Administrative Documents
WATTS BAR EXAM 2002-301

50-390
NOVEMBER 26 &
DECEMBER 9 - 13, 2002

Attached are the facilitie's marked exam questions. All comments were incorporated into the final exam.

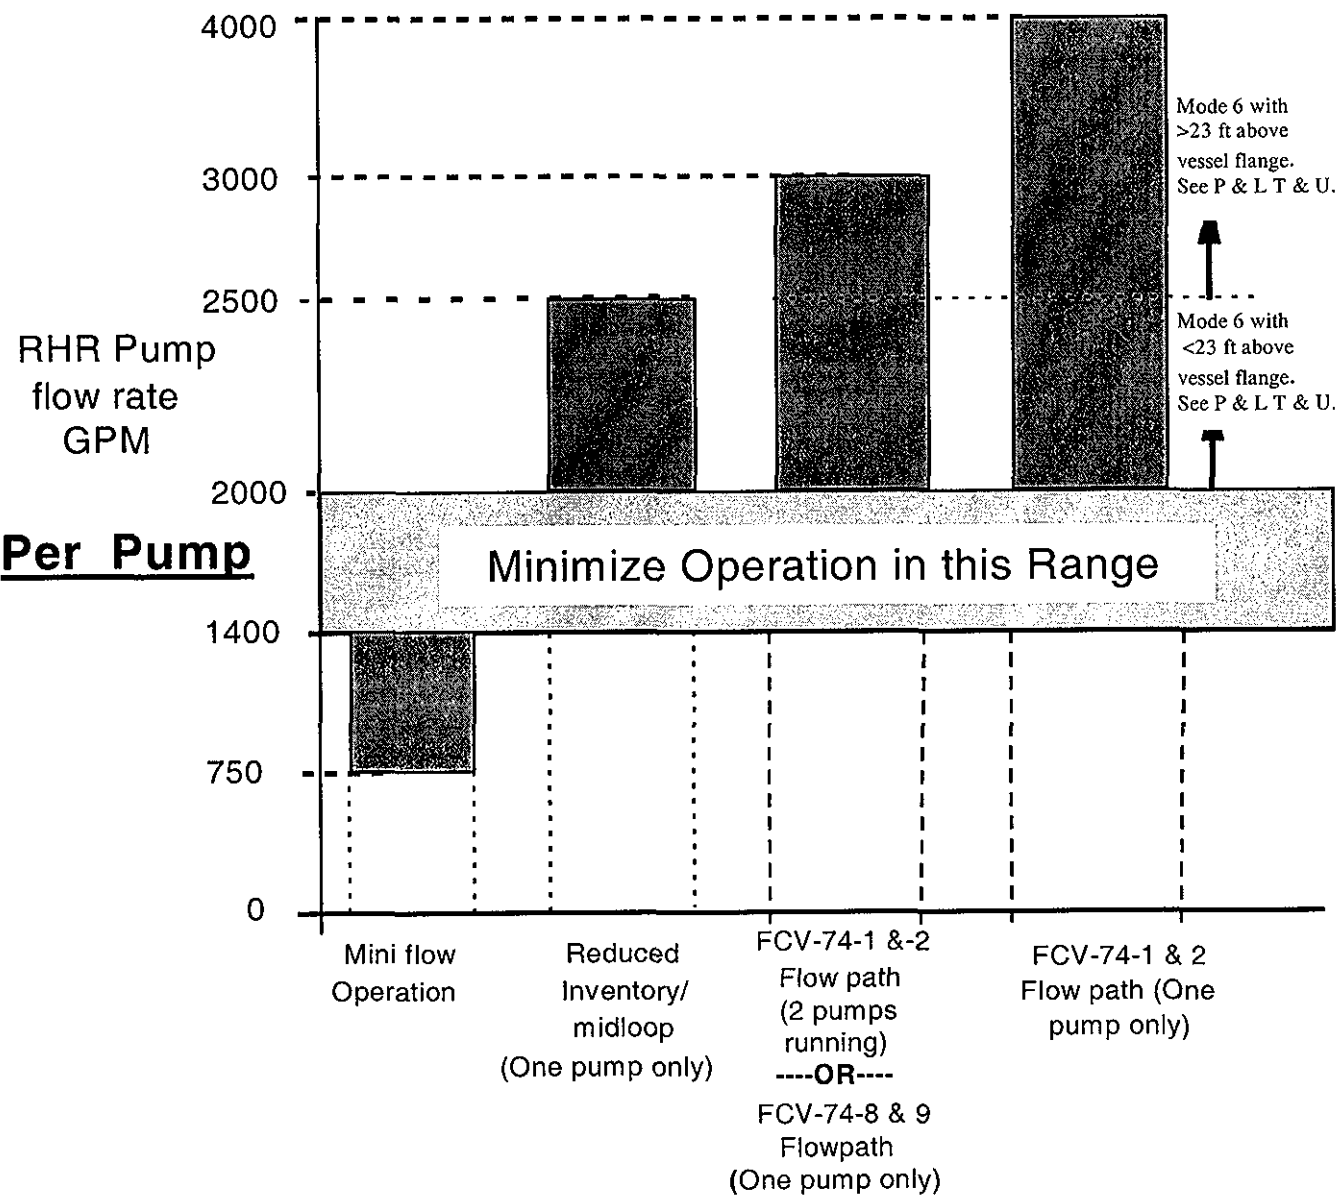
normal midloop level 718'6" to 719'
